Service Information

Recall Campaign 00V-048 - Brake Lamp Switch Replacement

E38 (7 Series)	produced 9/99 to 10/99
E39 (5 Series)	produced 9/99 to 10/99
E46 (3 Series)	produced 9/99 to 10/99

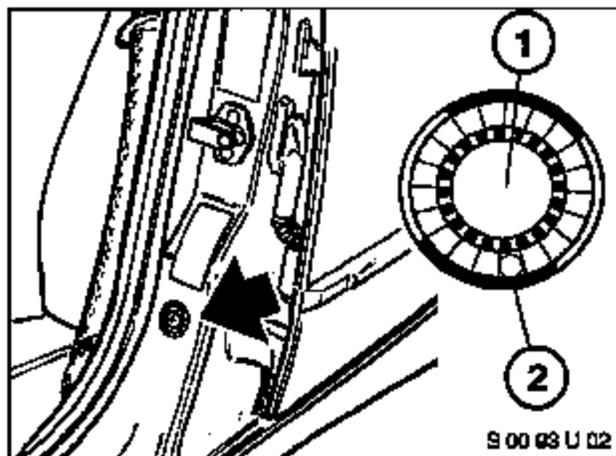
2. Check whether the brake light switch is marked with a white bar (1) at the connector end (2)

If the brake light switch is not marked with a white bar on the connector side, continue with step 3.

If the brake light switch is marked with a white bar (1), reinstall the lower footwell trim. No further actions are necessary.

3. Remove and replace the brake light switch (Refer to Repair Instruction 61 31 310)
4. Reinstall the lower footwell trim
